# UNITED STATES PATENT AND TRADEMARK OFFICE

10/815,372

**Office Action Summary**

### DETAILED ACTION

Fig 1

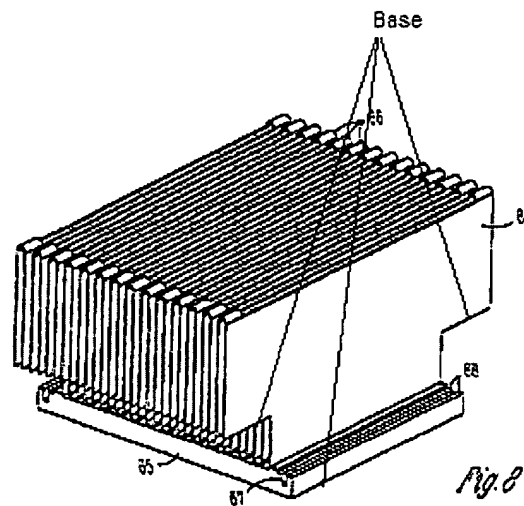
With respect to claims 17 and 18, as best can be understood by the Examiner, Bryant et al. in view of Wu teach the limitations of claims 1 and 6 above and further teaches that the base of the heat sink (32) has a long side and a short side (See Fig 2), whereby a boundary (The defined by the inside edge of 40a, 40b, 38a, and 38b) of the mounting device is located within and under the heat sink, but fails to teach that the mounting device has a length shorter than the long side of the base and a width shorter than the short side of the base. Lofland et al. teaches a mounting device (90) having a length (Defined by 92b, 92d) shorter than the long side of the base (See Present Office Action Fig 1 below) of a heat sink, and a width (Defined by 92a, 92c) shorter than the
